1701 GARVIN ST. REPLAT W. MODIFICATION OF STANDARDS

SUMMARY

<p><i>Updated: May 5, 2013</i></p>

PROPOSED SITE PLAN

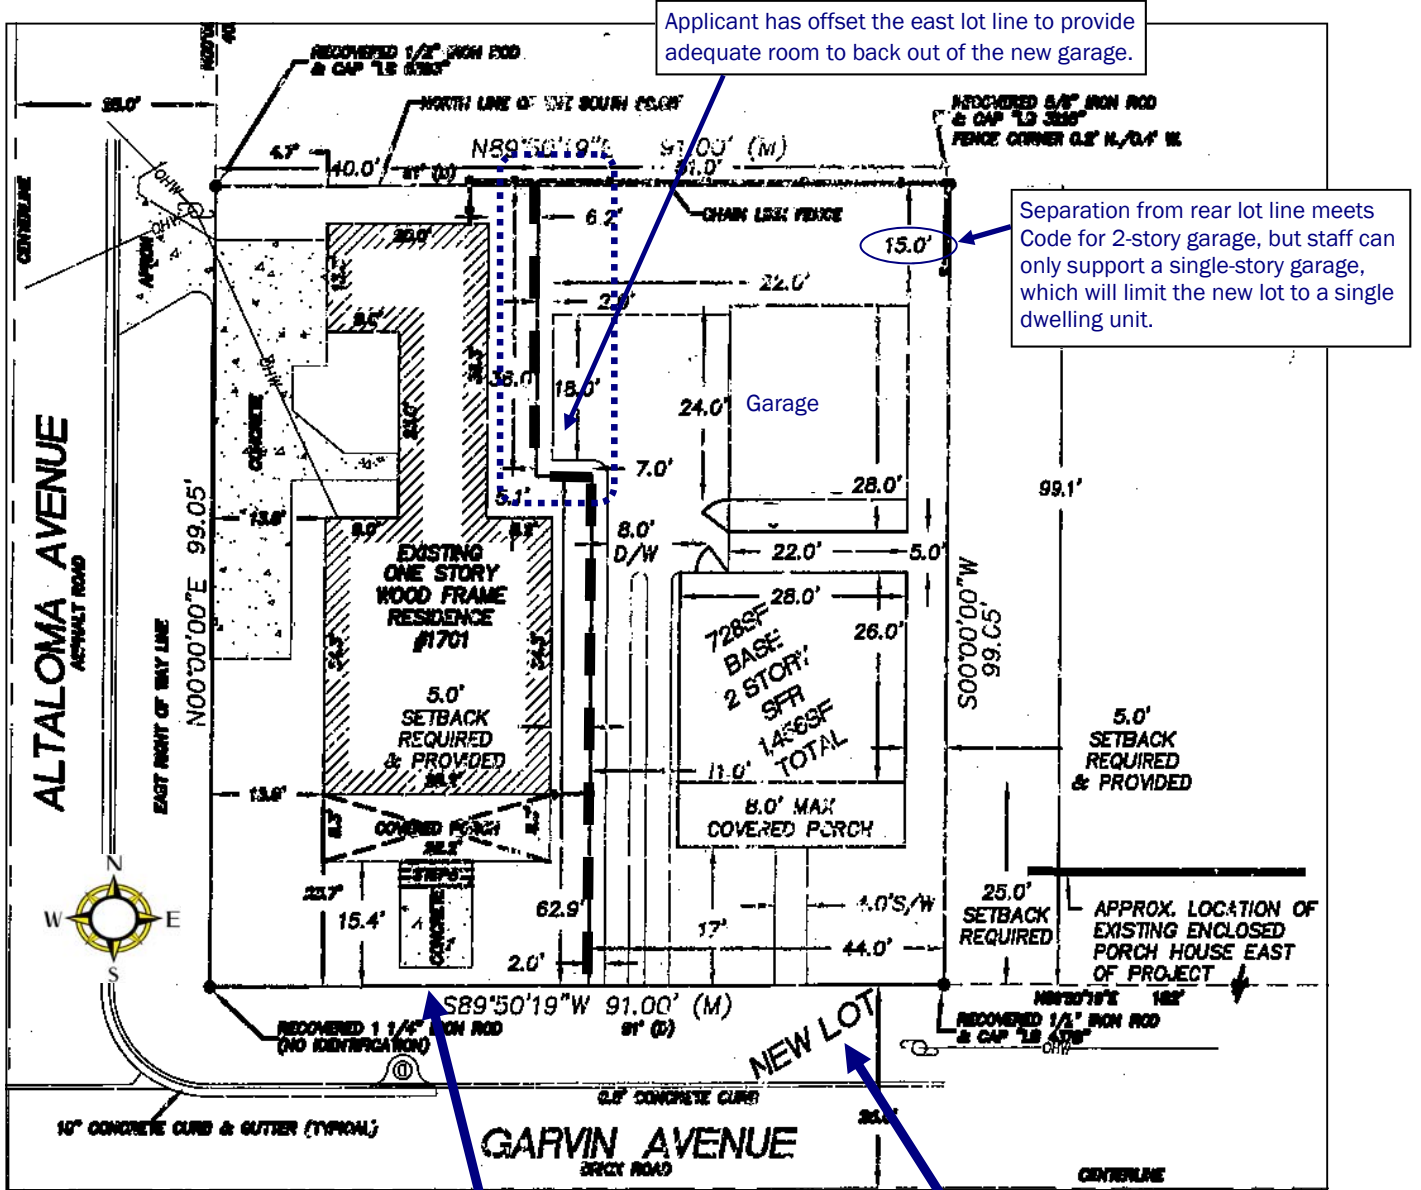
Per Table 2 at right, the lot does not meet the minimum lot depth requirement for R-2A/T/SP/AN zoning and requires a Modification of Subdivision requirements as part of the replat request. Per LDC Section 65.452, the following criteria apply to all plat-related Modification requests:

<i>R-2A/T/SP/AN</i> Single-Family Home	Lot 1 (existing home)	Lot 2 (new home)	
<i>Min. Lot Size</i> (sq. ft.) = 4,400	4,417.6 (0.10 ac.)	4,586 (0.11 ac.)	
<i>Min. Lot Dimensions</i> 40 ft. (w) x 110 ft. (d)	±44.6 x 99.05		±46.3 x 99.05
	<i>Existing</i>	<i>W. Mod.</i>	
Imperv. Surface Ratio (ISR)(55%)	28%	56%	51%
Setbacks - Front (min. 25 ft.)	32	32	25 ft.
St. Side (15 ft.) Side (5 ft.)	13.8/49	13.8/5	12 (w) & 5 (e) ft.
Rear (min. 25 ft.)	4.7	4.7	47 ft.

ELEVATIONS & FLOORPLAN FOR PROPOSED GARAGE

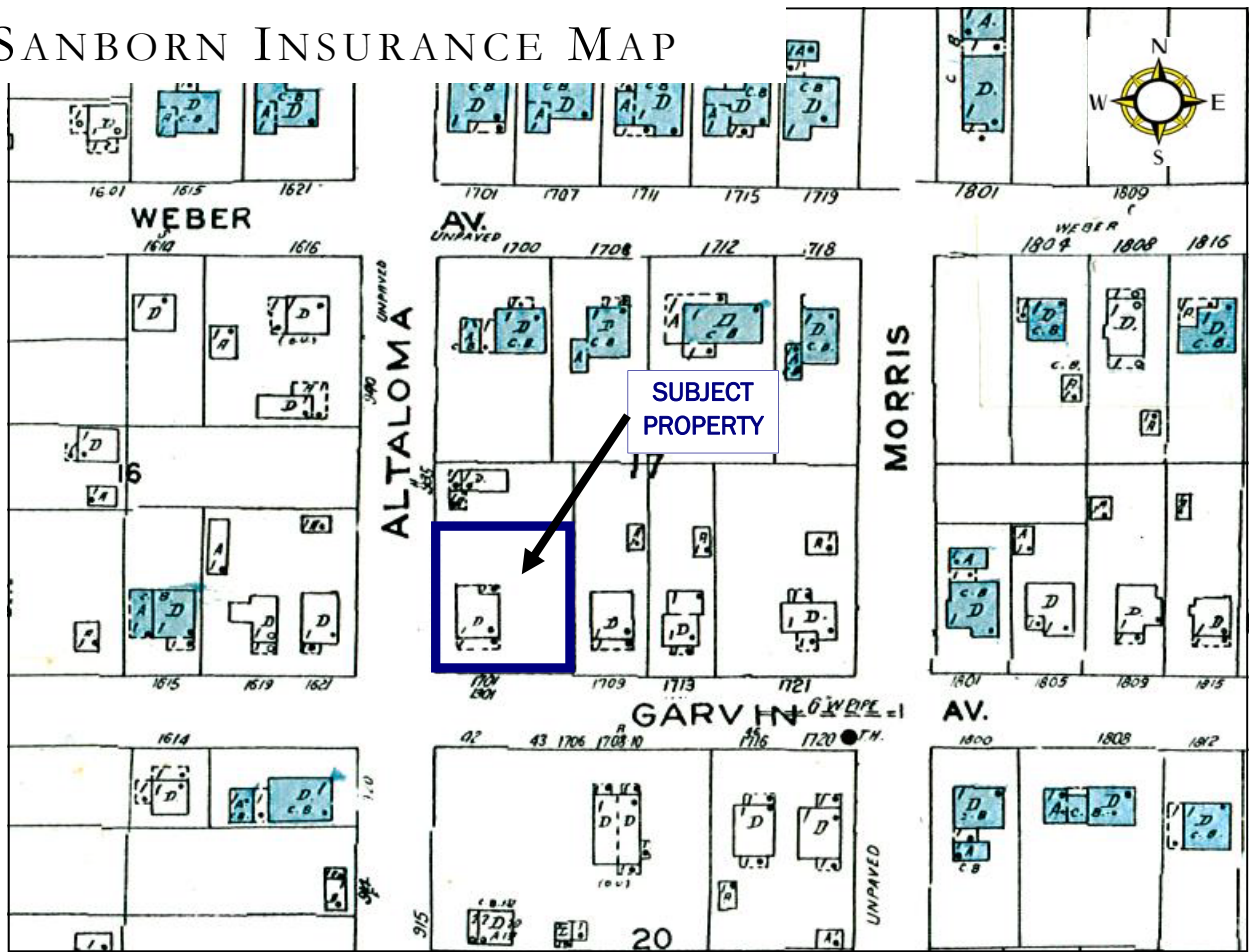
Staff can only support a single-story garage, which will limit the new lot to a single dwelling unit.

1. ISR - Prior to receiving a Certificate of Occupancy on new house, one (1%) percent of the existing impervious surface on or around the existing residence at 1701 Garvin shall be removed to meet the 55% Code maximum ISR for that lot.
2. Garage - If detached, the proposed garage shall be of single-story design. If the garage is attached to the house, the house shall meet the minimum 25 ft. rear yard setback.
3. Consistency - The proposed improvements must be consistent with the size, dimensions, site location, and appearance shown on the plans that was submitted with this application and as described elsewhere in this staff report.
